International Aero Engines SERVICE BULLETIN

AIR - COOLING - IGNITION COOLING LEADS -
INTRODUCTION OF NEW IGNITION EXCITER
COOLING TUBES

EC94VR046

V2500-ENG-75-0043

Figure 3

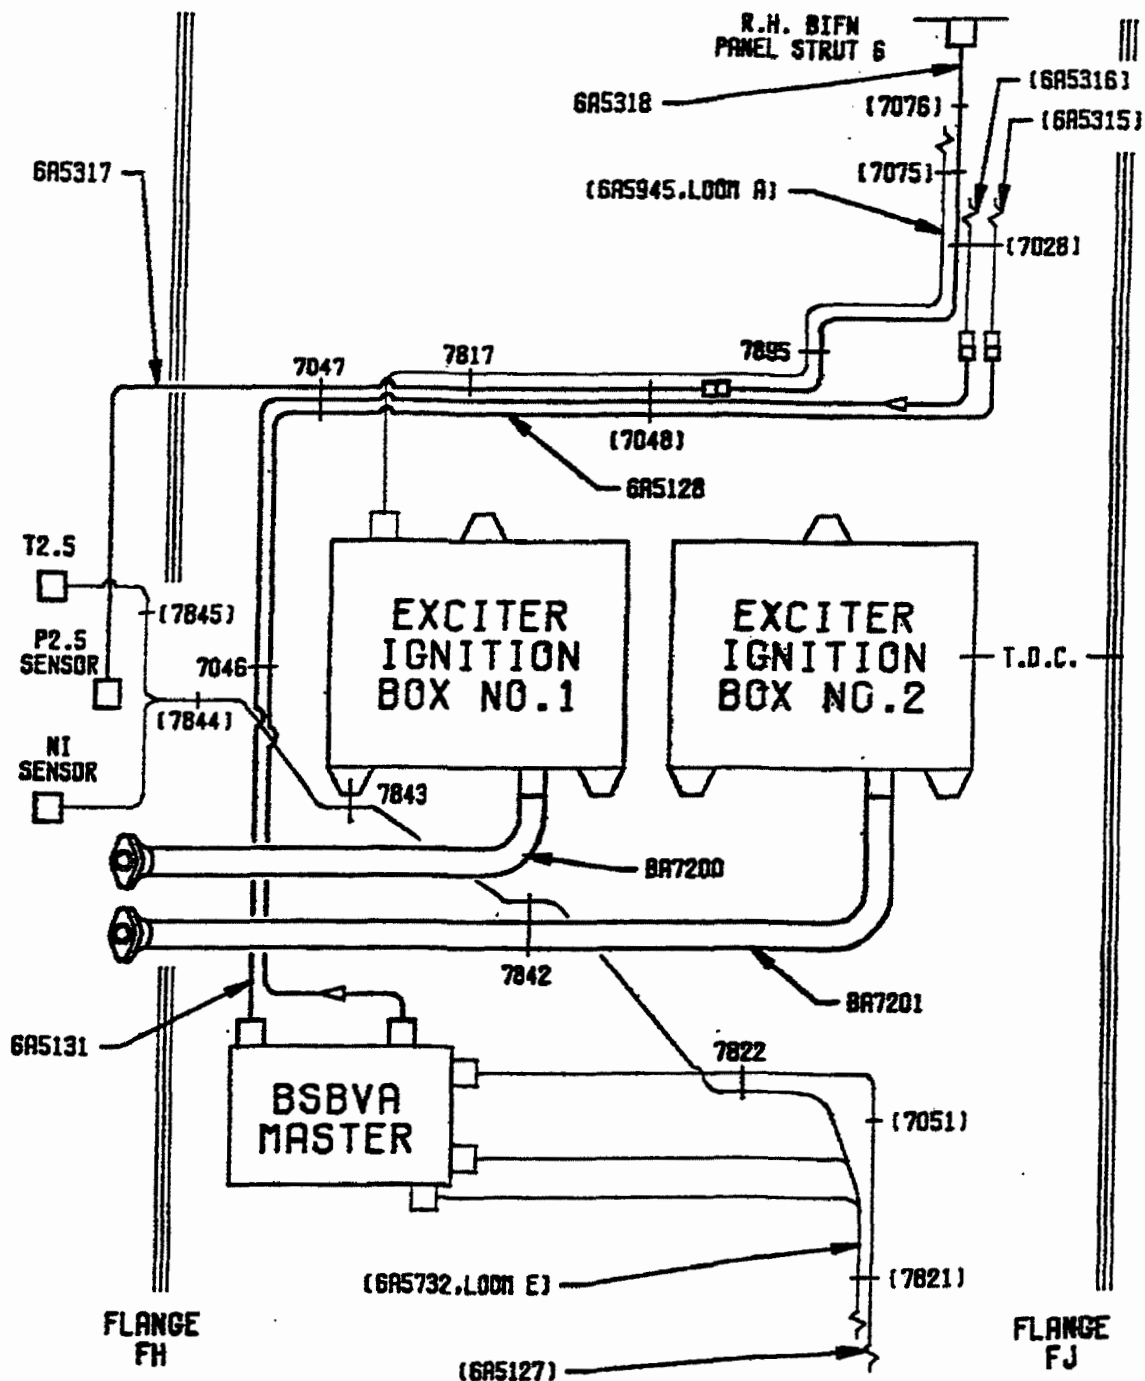
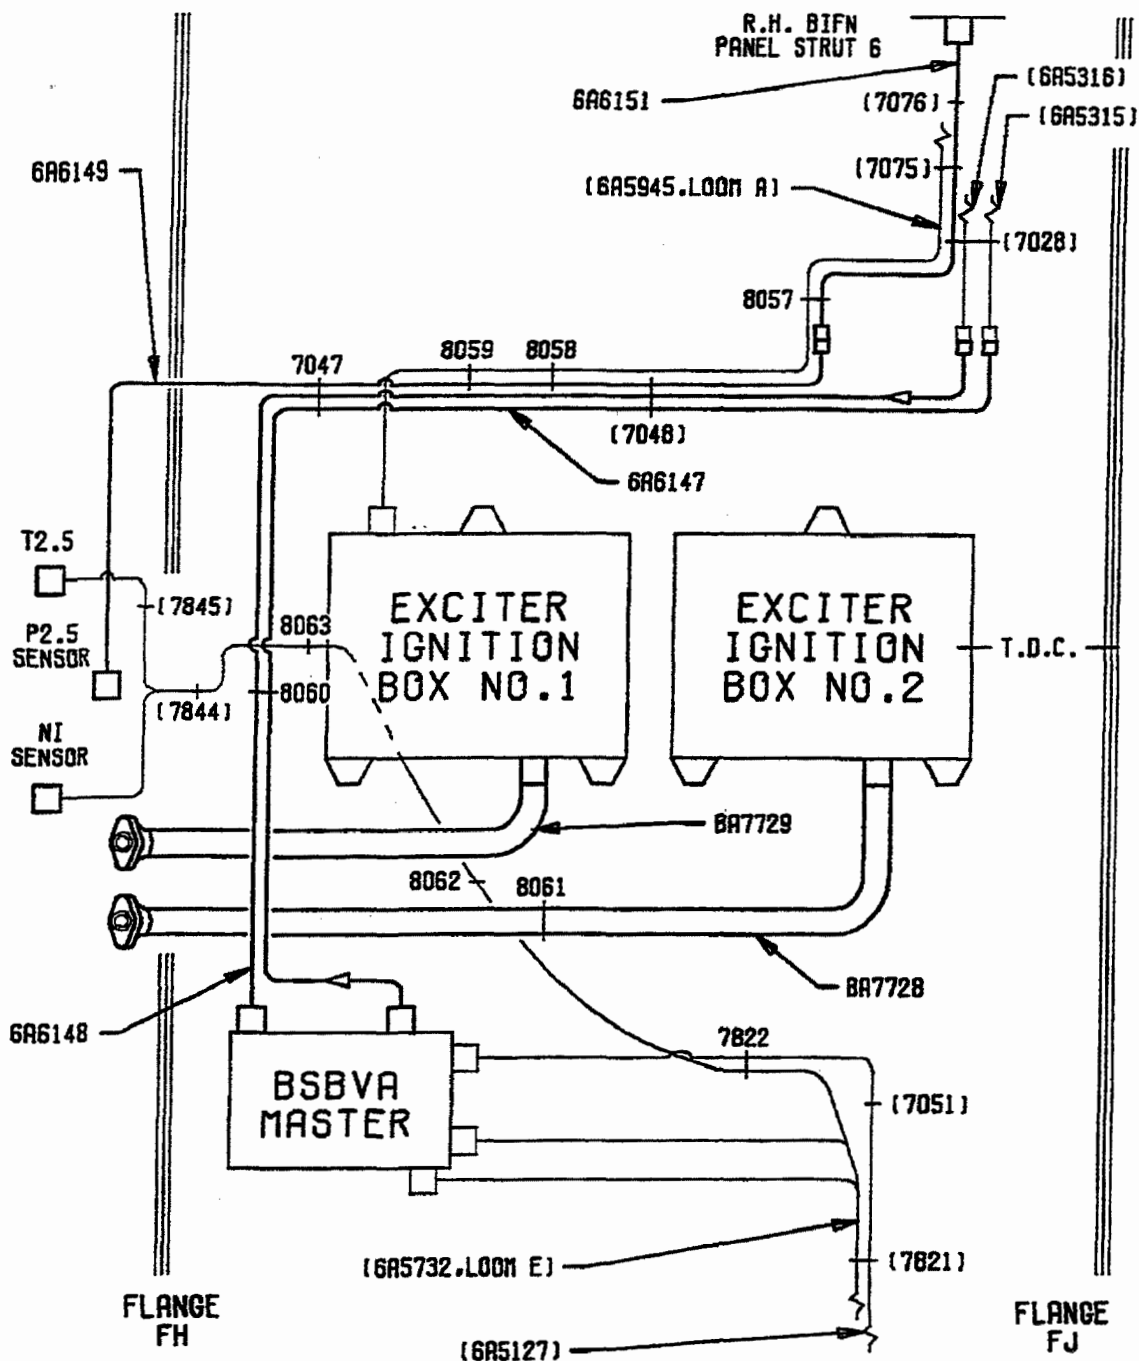
- (1) Two new Ignition box cooling air flexi-hoses replacing the existing hoses.

Two new fuel tubes, BSBVA master to disconnect and disconnect to BSBVA master. These fuel tubes now run above rather than below the Ignition flexi-hoses.

- (3) Loom A is now clipped at CP8057, CP8058 and CP8059 which replace CP7817 and CP7895. Loom A is physically unchanged. Loom E is now clipped at CP8062 and CP8063 which replace CP7842 and CP7843. Loom E now runs below Ignition box No.1 from CP8062 to CP8063 and is physically unchanged.

- (4) Run the loom E harness 6A5732 under the 6A5127 fuel tube to the Master BSBVA, under the No.1 ignition exciter box and forward to the T2.5 and fan trim balance probe terminals. Refer to Figure 3.

- (11) Loosely install the existing clamps to either end of the new BA7728 and BA7729 ignition exciter cooling air tubes. Install the tubes to their respective ignition exciter box and fan frame fittings. Tighten the clamp screws by hand. Refer to Figure 3.

- (13) Install a new MS9967-011 sealing ring onto each of the master BSBVA servo tube connectors. Connect the new 6A6147 and 6A6148 servo fuel tubes to the master BSBVA. Torque the tube coupling nuts to 204 to 221 lbfin (23 to 25 Nm). Wire lock the nuts using CoMat 02-126 lockwire. Refer to Figure 3.

Figure 4

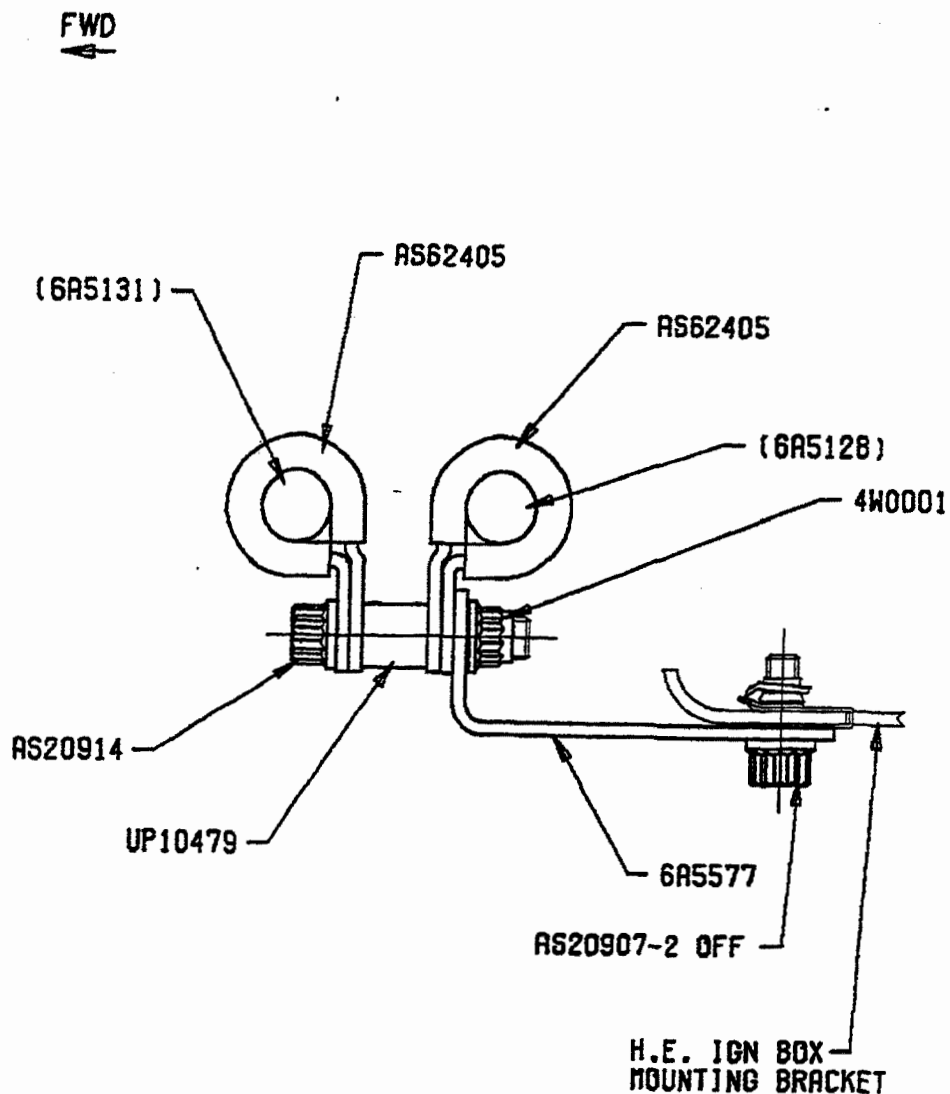
Clipping points CP7046, CP7817, CP7842, CP7843 and CP7895 are deleted.

Clipping point 7046
- Deleted

- (8) Clip the loom E harness 6A5732 to the 6A5952 bracket at clipping point 8063 using the AS21047 bolt, AS62503 clip and the 4W0001 nut that was previously used at clipping point 7046. Torque the bolt to 36 to 45 lbfin (4 to 5 Nm). Refer to Figures 3, 4, 13 and 14.

Figure 5

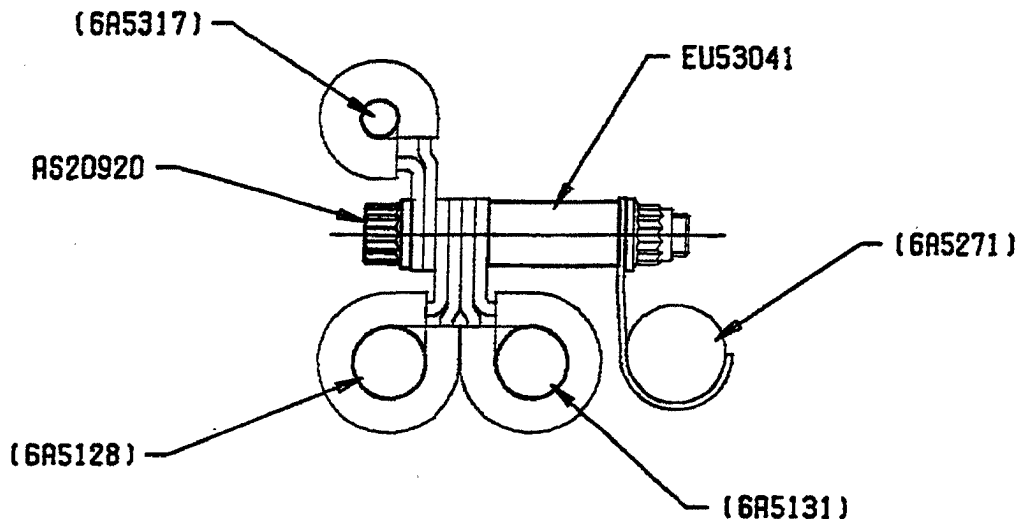
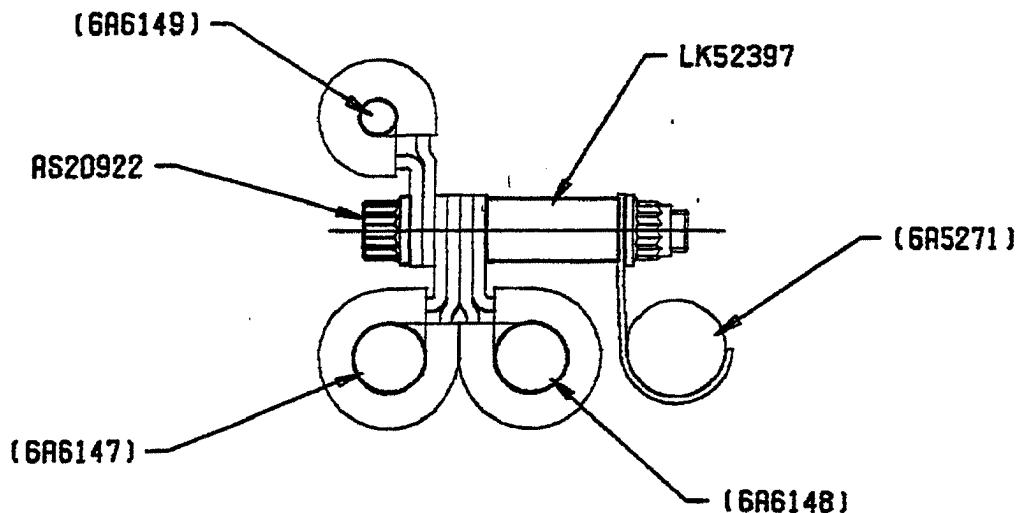
- (4) Clipping points CP7047 and CP7822 are amended to accommodate the new tube and harness runs.

CLIPPING POINT 7047 - BEFORE ALTERATION
LOOKING FORWARDS

CLIPPING POINT 7047 - AFTER ALTERATION
LOOKING FORWARDS

- (15) Clip the P2.5 air tube and BSBVA servo fuel tubes at clipping point 7047 using the new AS20922 bolt and 1K52397 spacer in addition to the remaining existing material. Torque the bolt to 36 to 45 lbfin (4 to 5 Nm). Refer to Figures 1, 3 and 5.

Figure 6

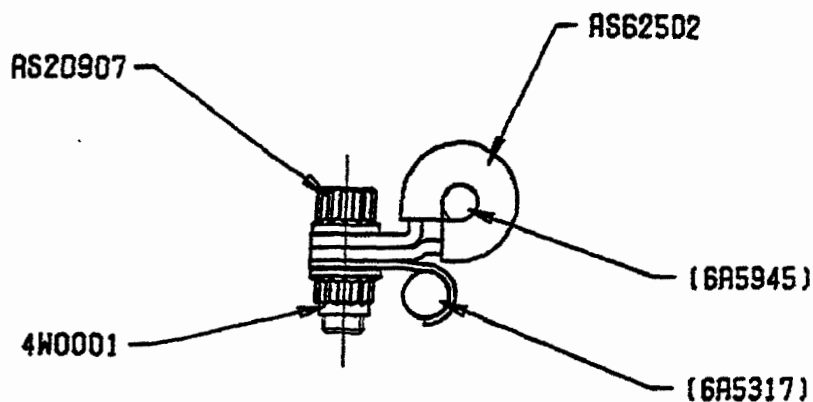
Clipping point 7817
- Deleted (Looking rearwards)

Figure 7

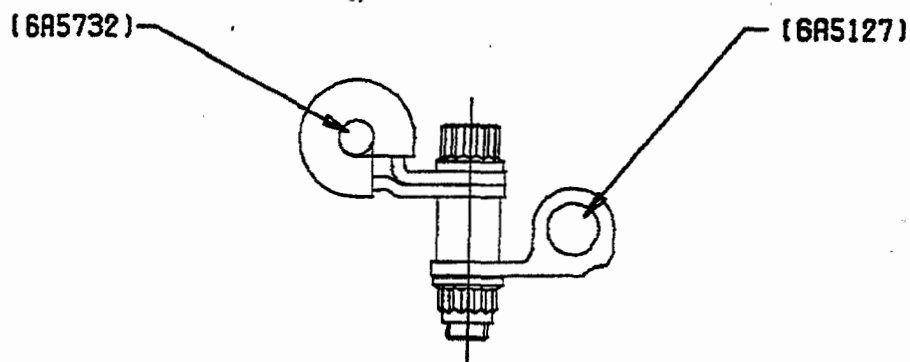
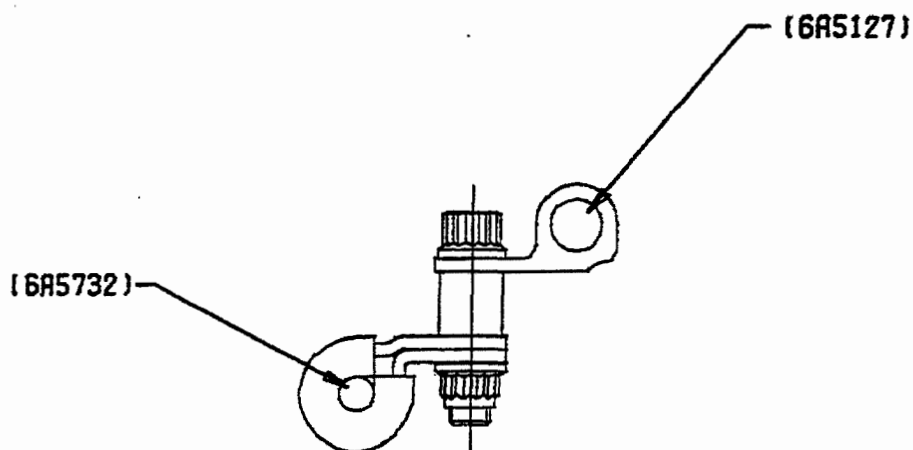
CLIPPING POINT 7822
BEFORE ALTERATION
LOOKING FORWARDS

CLIPPING POINT 7822
AFTER ALTERATION
LOOKING FORWARDS

- (9) Install the loom E harness 6A5372 at clipping points 7822, 7844 and 7845 using the existing material. Note the new arrangement of clipping point 7822. Torque the bolts to 36 to 45 lbfin (4 to 5 Nm). Refer to Figures 3 and 7.

Figure 8

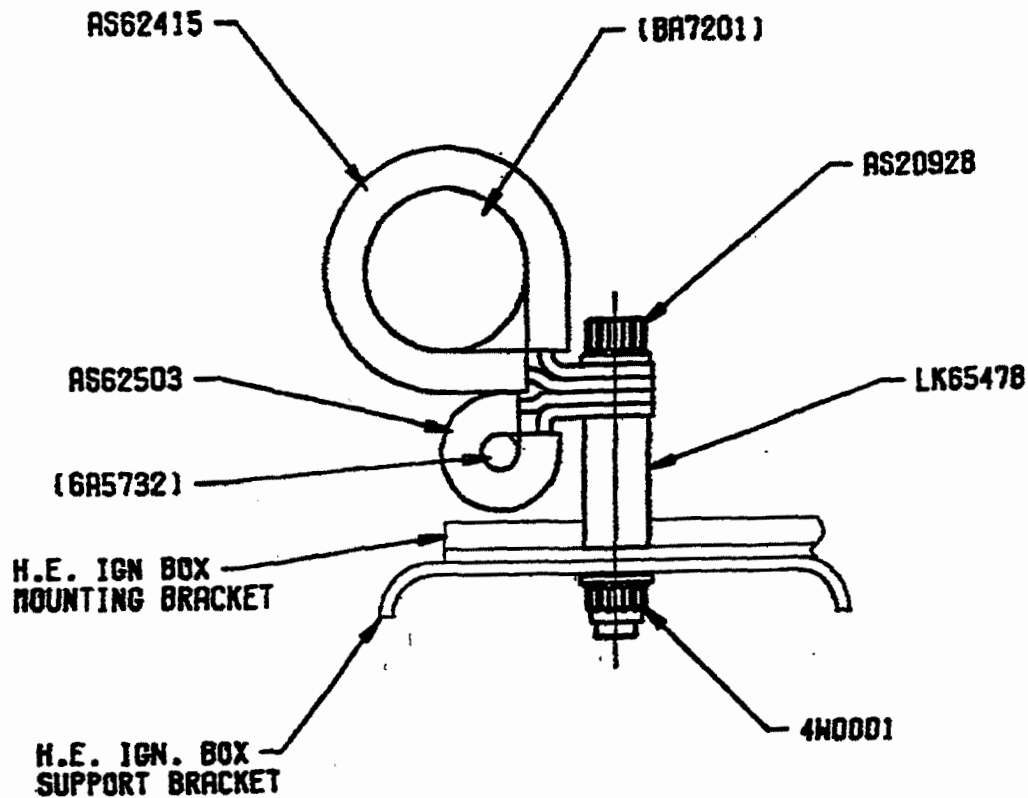
Clipping point 7842
- Deleted (Looking forwards)

Figure 9.

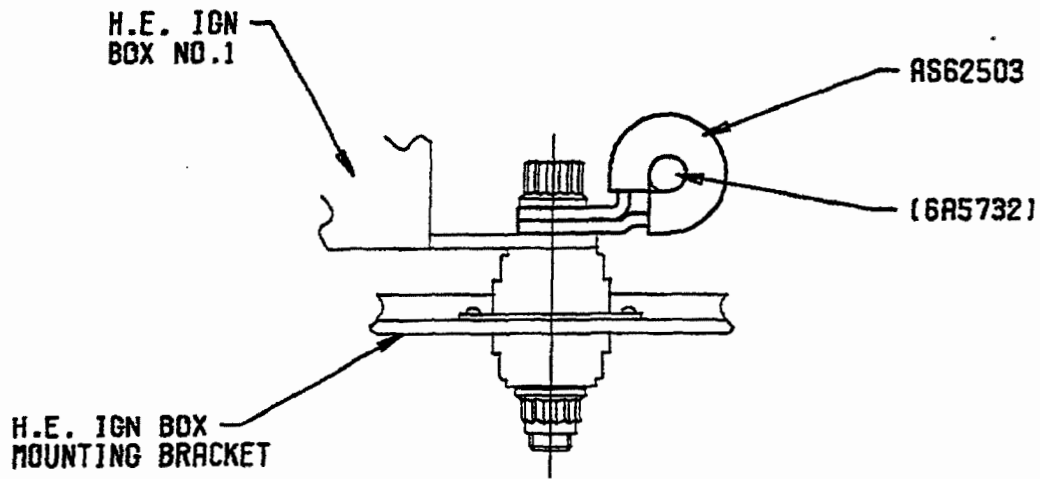
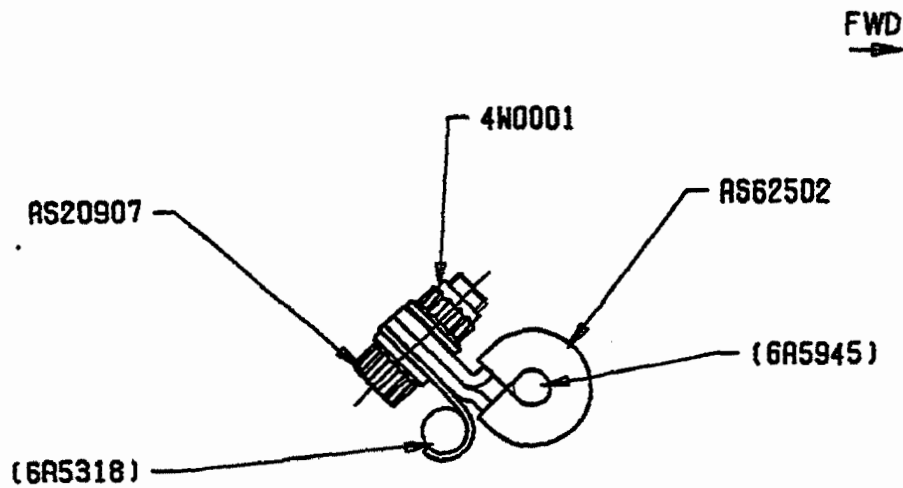
CLIPPING POINT 7843 - DELETED
LOOKING REARWARDS

CLIPPING POINT 7895 - DELETED

- (1) Install the bolt and nut, but not the clip, previously used at clipping point 7843. Torque the bolt to 36 to 45 lbfin (4 to 5 Nm). Refer to Figures 1, 2 and 9.

Figure 10

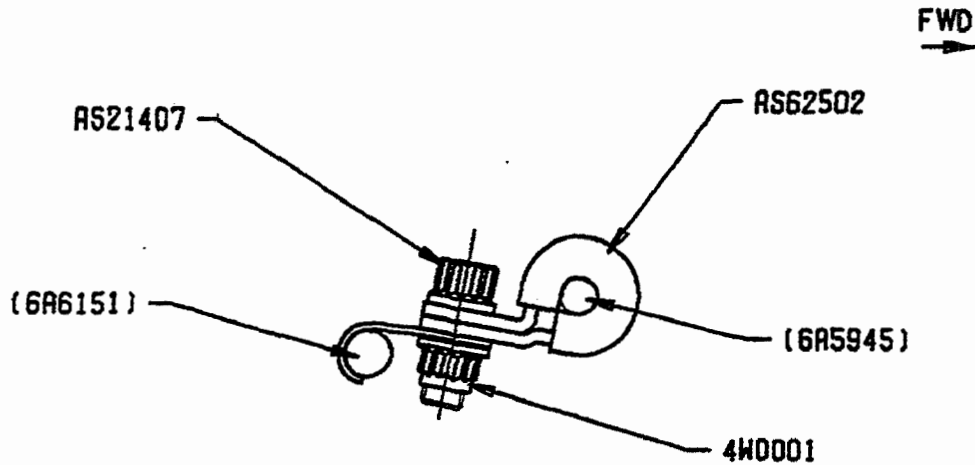
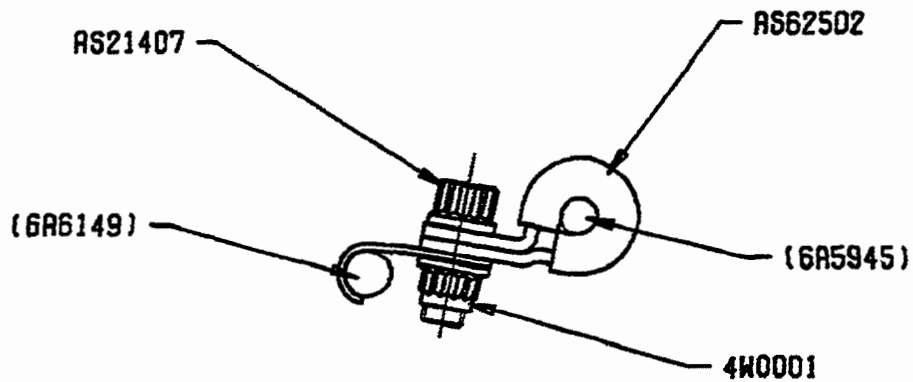
CLIPPING POINT 8057 - ADDED

CLIPPING POINT 8058 - ADDED
LOOKING FORWARD

- (19) Clip the loom A harness to the P2.5 air tube at clipping points 8057, 8058 and 8059 using the AS21407 bolts, AS62502 clips and 4W0001 nuts. Torque the bolts to 36 to 45 lbfin (4 to 5 Nm). Refer to Figures 3, 10 and 11.

Figure 11

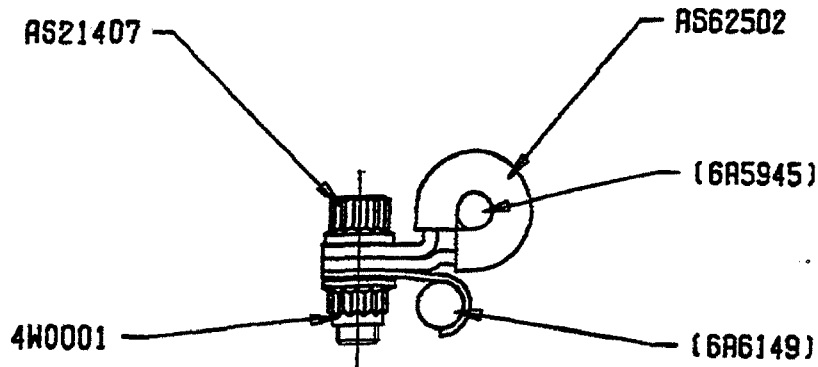
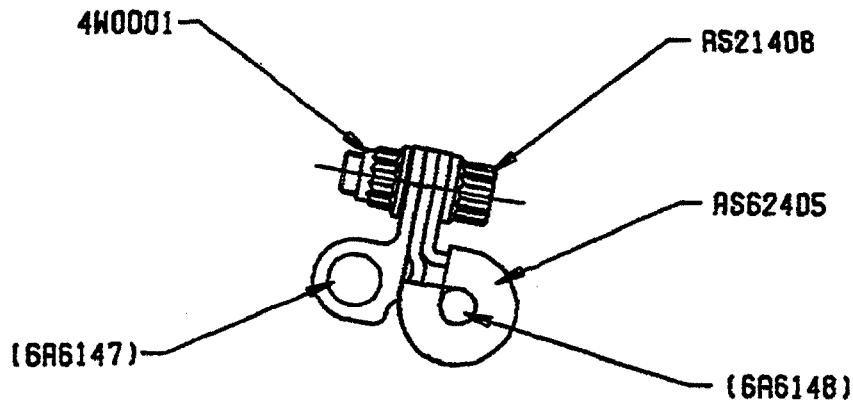
CLIPPING POINT 8059 - ADDED
LOOKING REARWARDS

CLIPPING POINT 8060 - ADDED

- (20) Clip the 6A6148 servo fuel tube to the 6A6147 servo fuel tube at clipping point 8060 using the AS21408 bolt, AS62405 clip and 4W0001 nut. Torque the bolt to 36 to 45 lbf·in (4 to 5 Nm). Refer to Figures 3 and 11.
- (21) Visually check the clearance, C, between the BA7729 ignition exciter cooling air tube and the master BSBVA servo tubes, 6A6147 and 6A6148, and also the clearance, D, between the BA7729 tube and the igniter box securing bolt. If these clearances are visually unequal then loosen the clamp at the igniter box end of the BA7729 tube and rotate the tube on the igniter box fitting until the clearances appear equal. Tighten the clamp screw by hand. Refer to Figure 15.
